## Addendum No. 2

Reference: Mechanical/Electrical/Plumbing Upgrades – Miller Administration Building  
Weber State University – Ogden, Utah  
DFCM Project No. 14031810

## ADDENDUM #2

Project: Weber State University  
Miller Administration M.E.P. Upgrades  
3848 Harrison Boulevard  
Ogden, Utah 84401

Sheet Number  
**ME902**

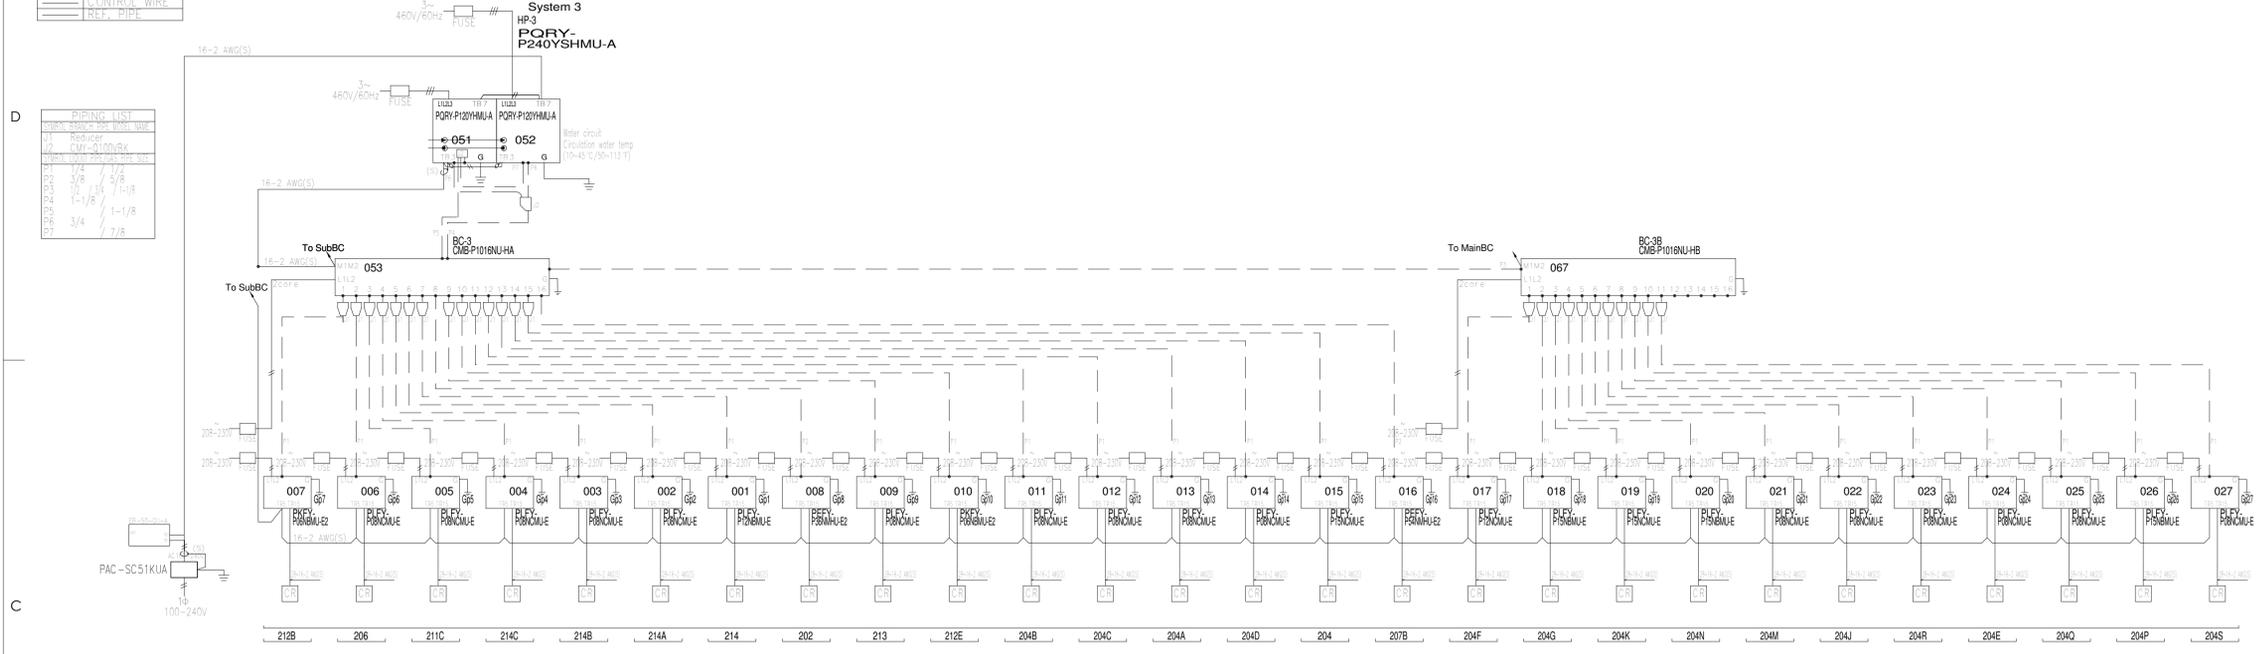
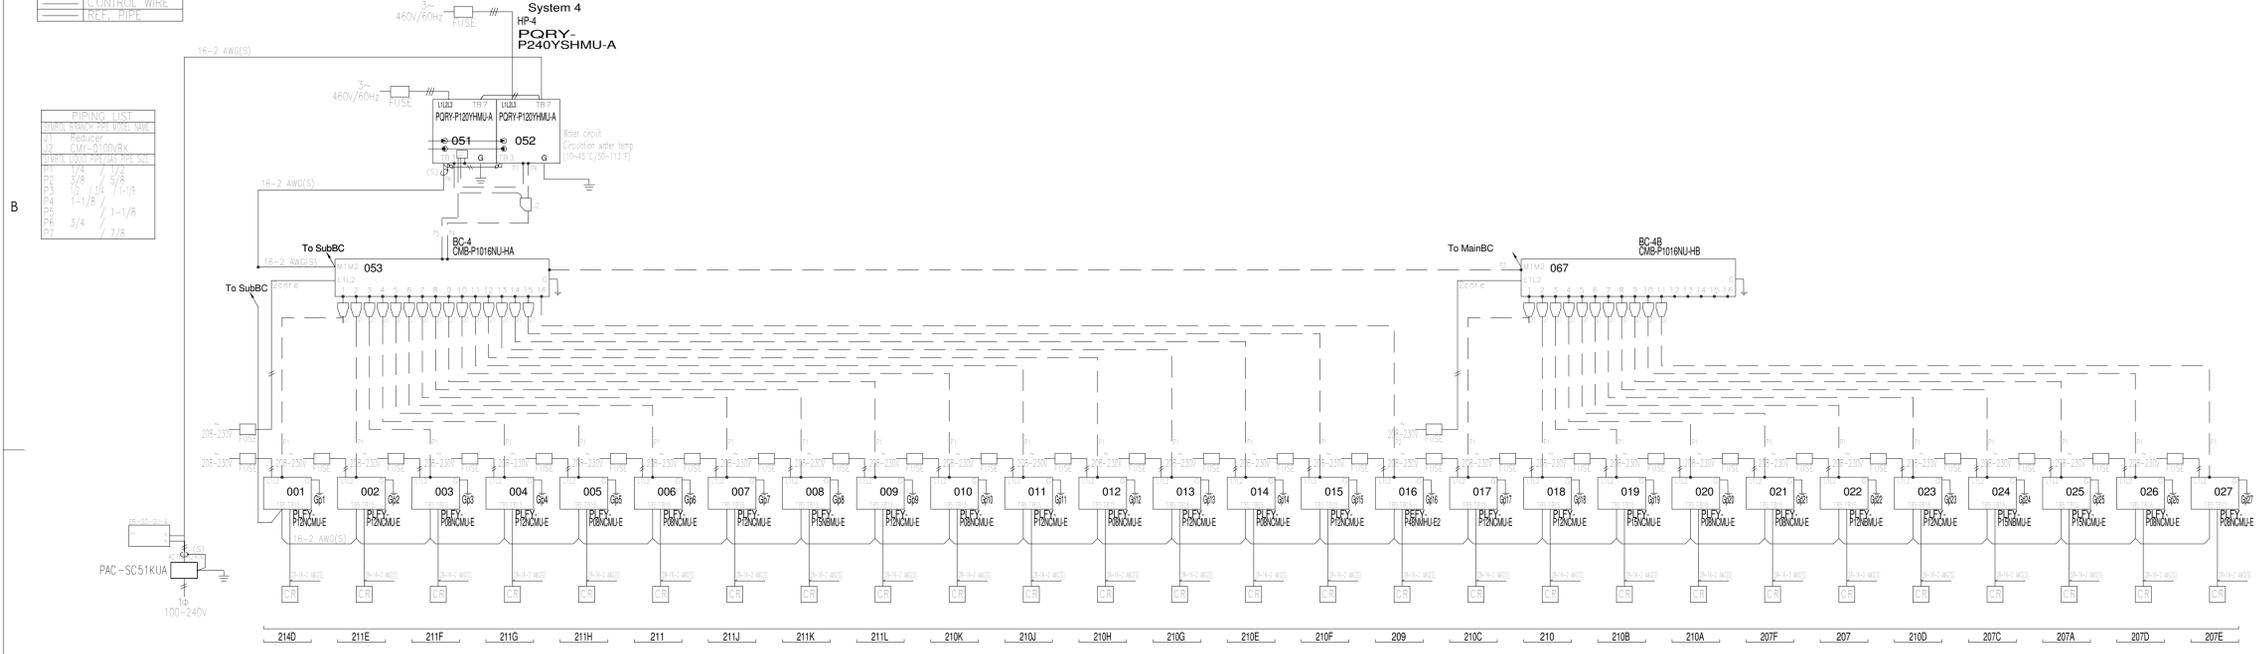
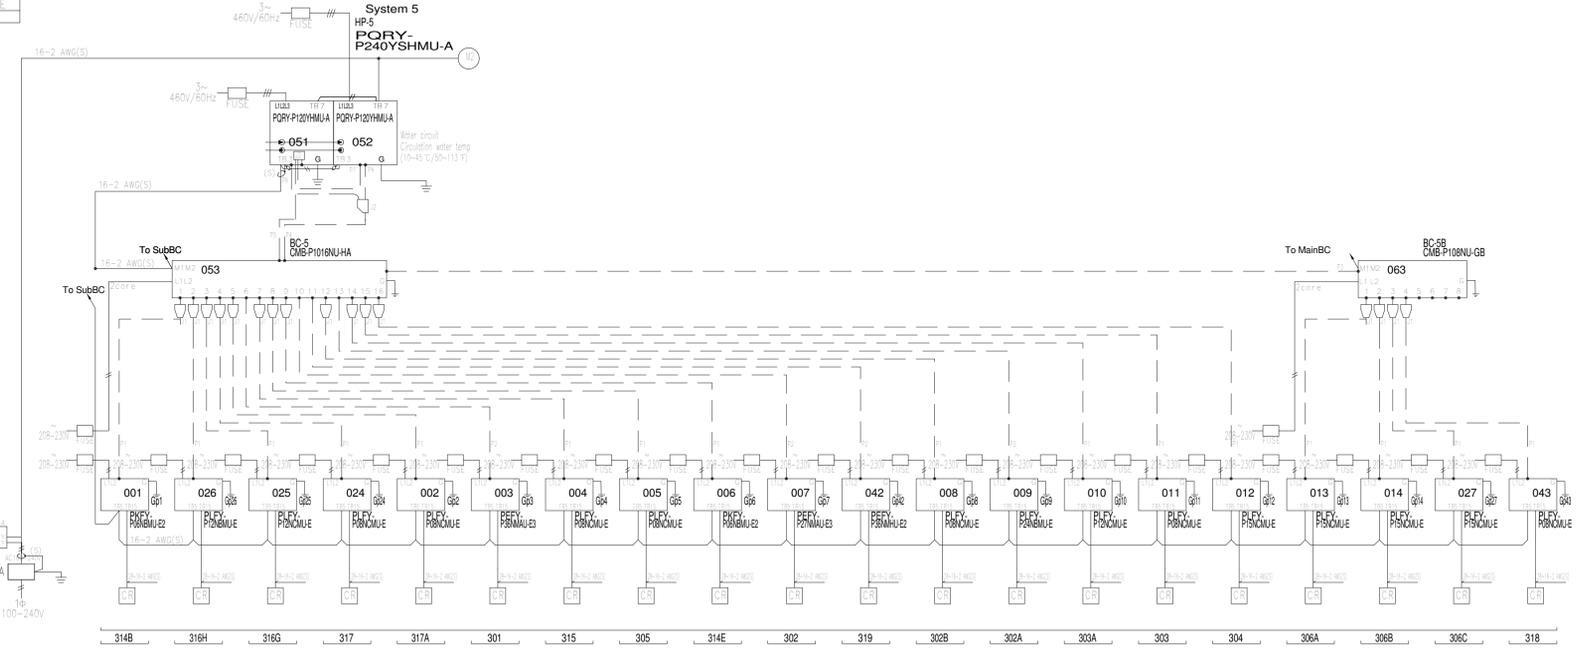
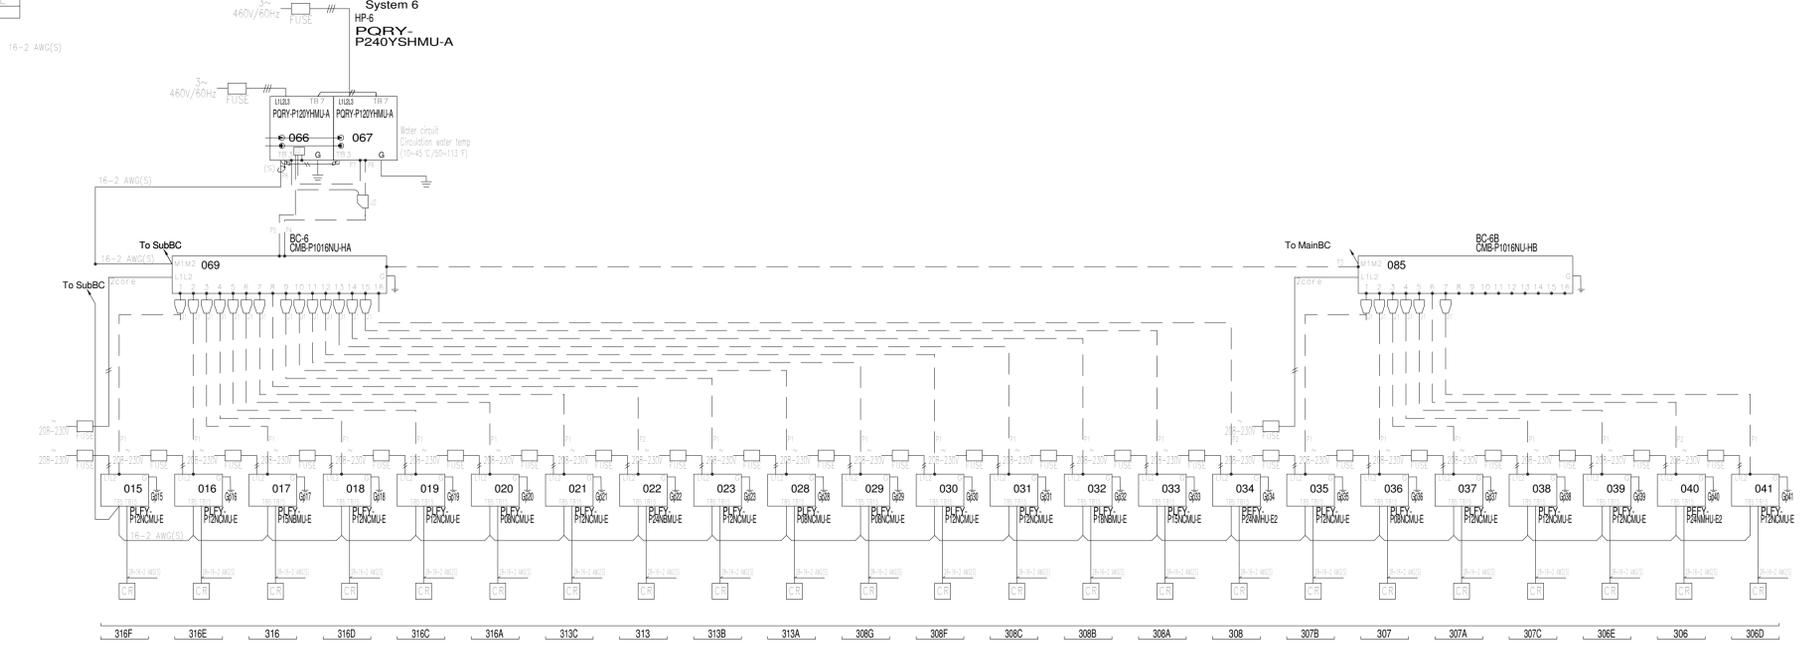
- Item II-4.** Added a note on sizing the refrigerant piping for the VRF systems to the schedules. See attached updated ME602 and ME603.
- Item II-5.** Updated the VRF Schematics and made them more readable. See attached updated ME902, ME903, and ME904.
